Grimes City Council Agenda

Grimes City Council Meeting June 22, 2021 In Person/Zoom at Grimes Community Center, 410 SE Main Street

- E. Crossroads Plat 4, Preliminary Plat
- F. Crossroads Plat 4 Site Plan
- G. Report and Status Update on Water Distribution

SHEET NUMBER:
C5.0
2012.718

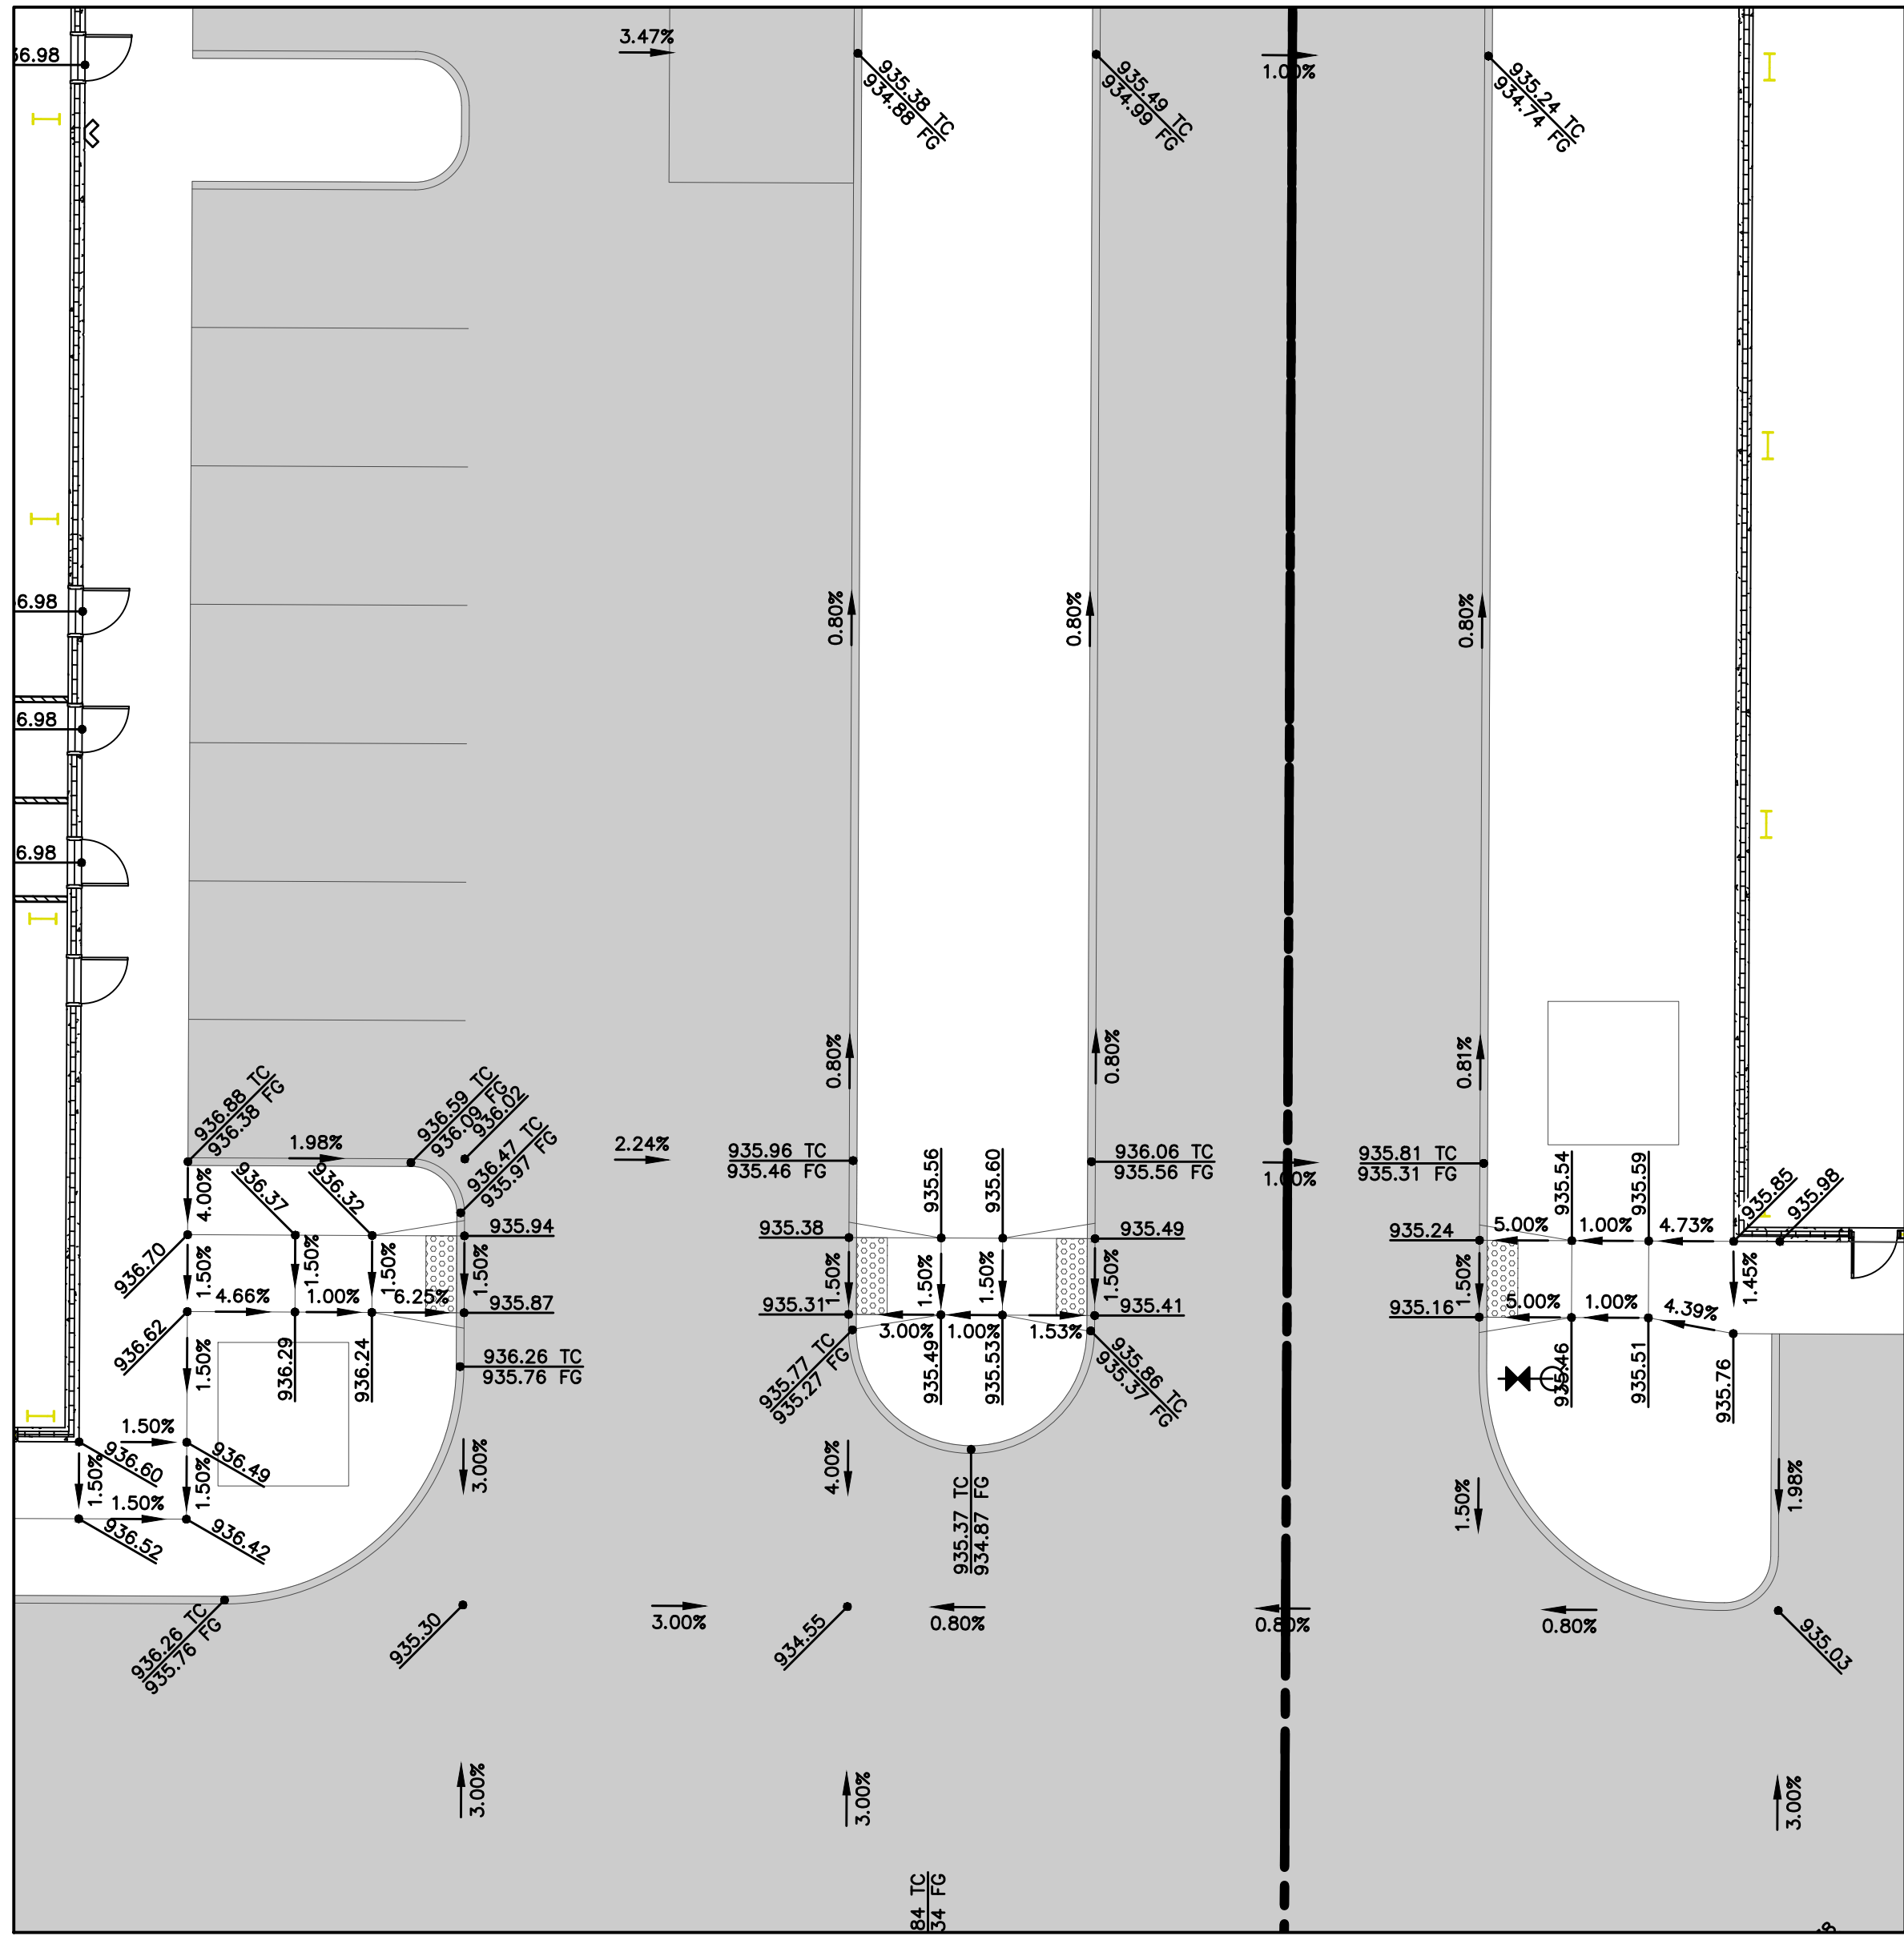
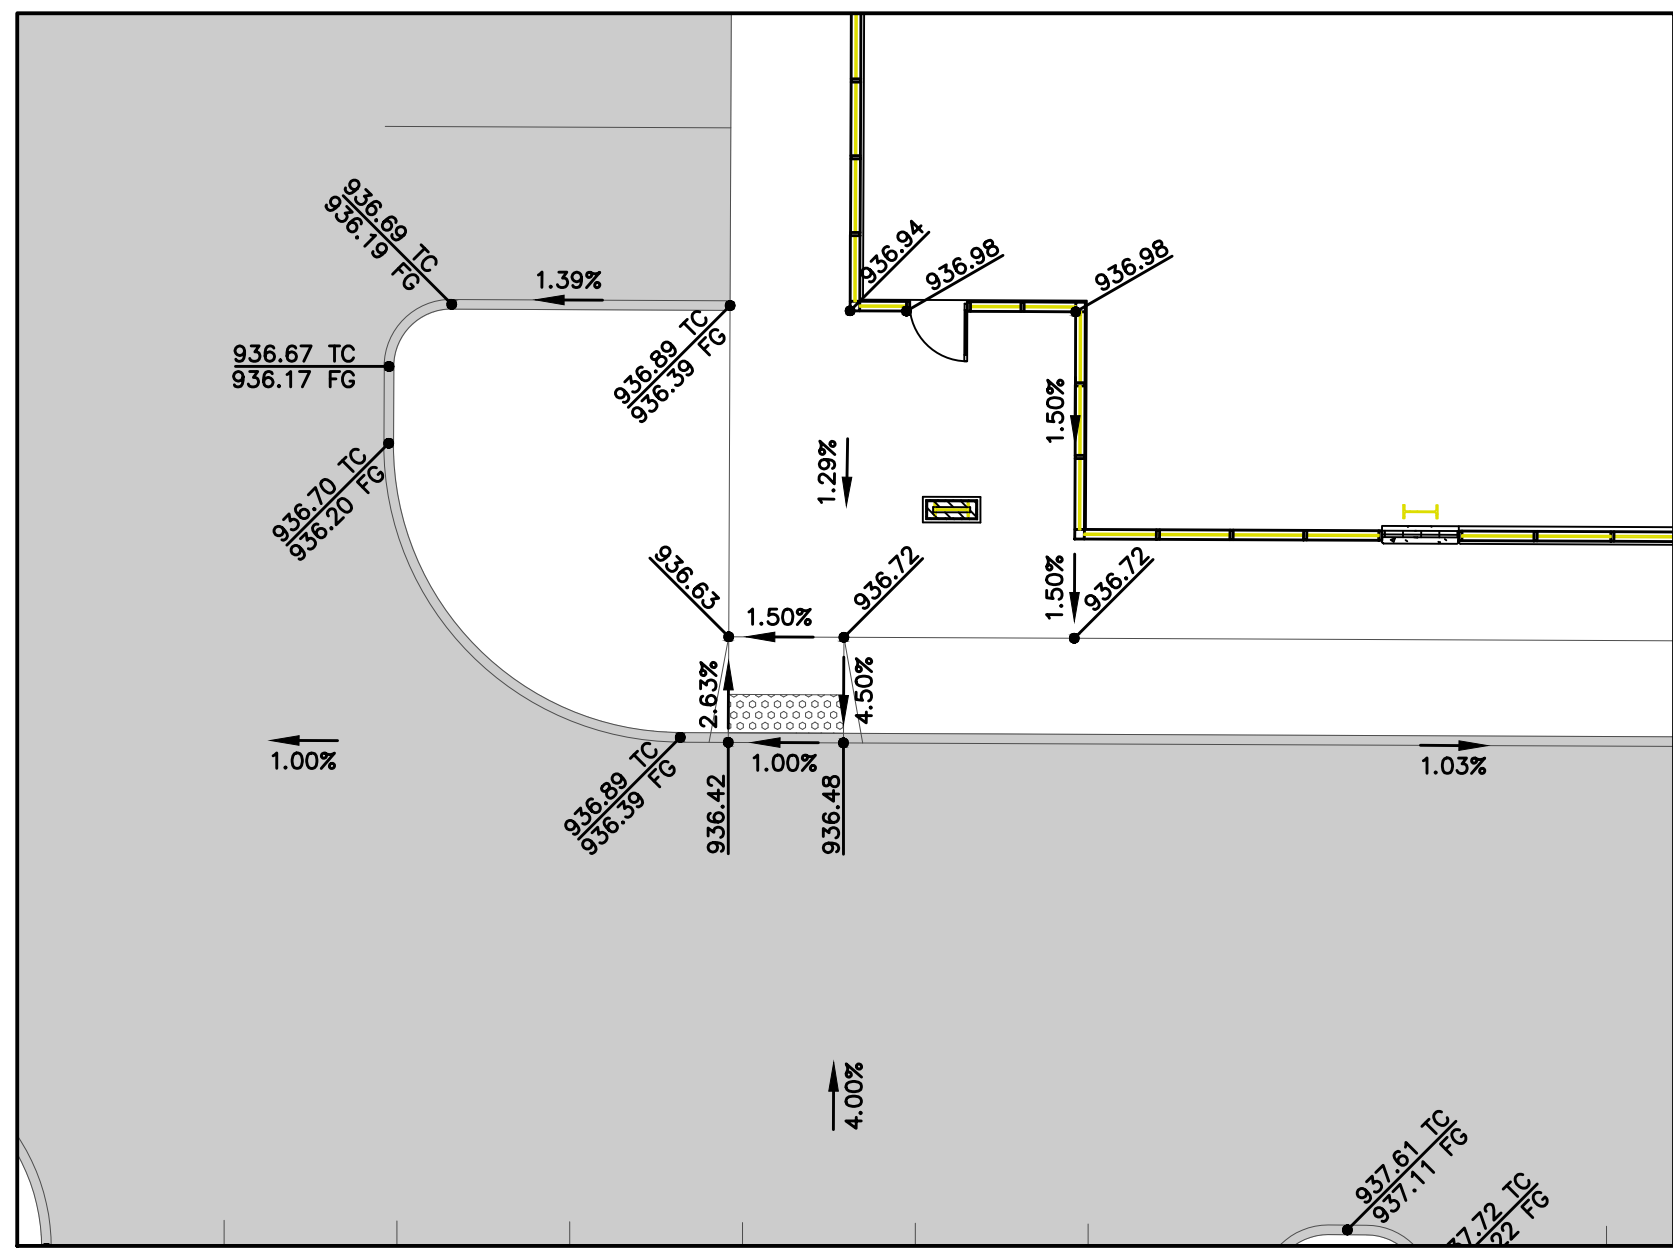
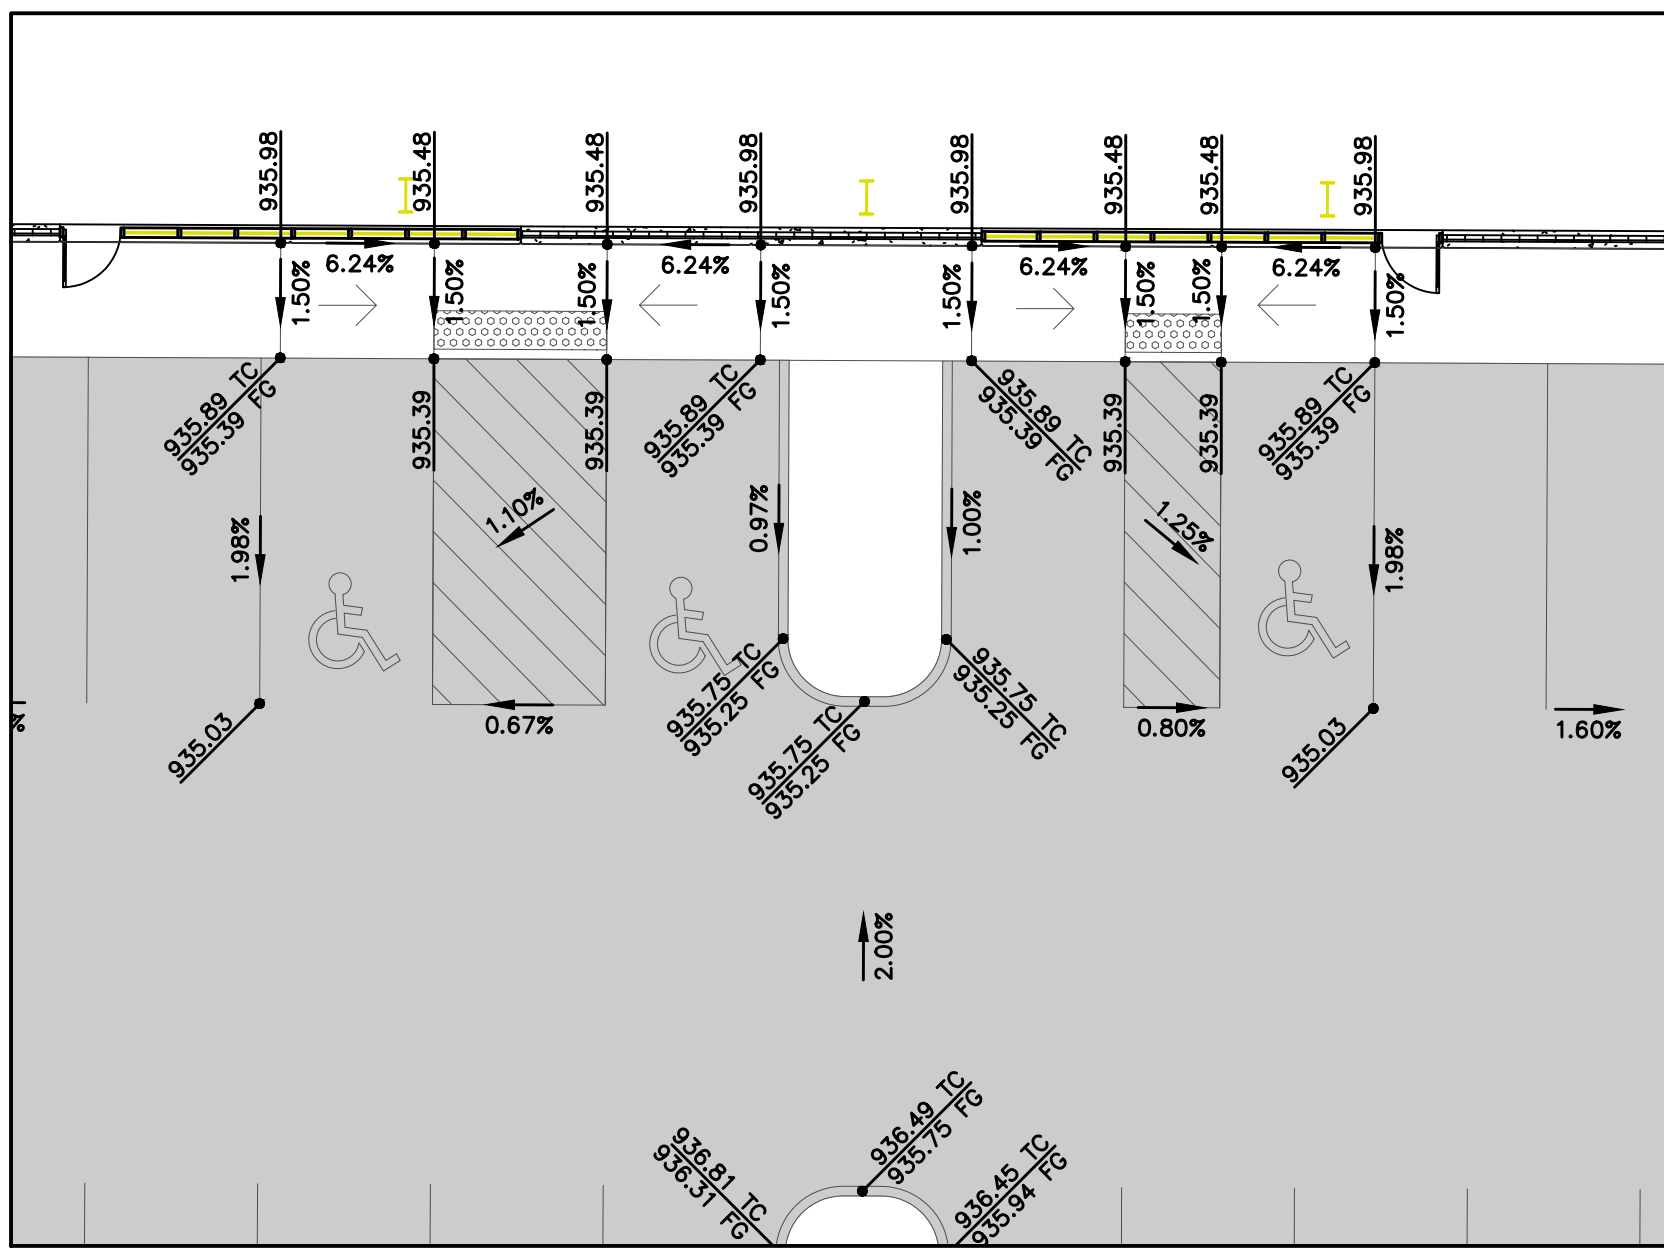
- ~~1. C5.0: Provide emergency overflow and protection on basin.~~
- ~~2. C7.0: Provide detail for ST-2 and perforated riser.~~
- ~~3. C7.0: Do buildings require roof drain connections?~~
- ~~4. C7.0: How will the DA going to the future parking expansion be captured?~~
5. C5.0 & C9.1: Label basin as bioretention pond and provide cross-sectional detail of basin layers.
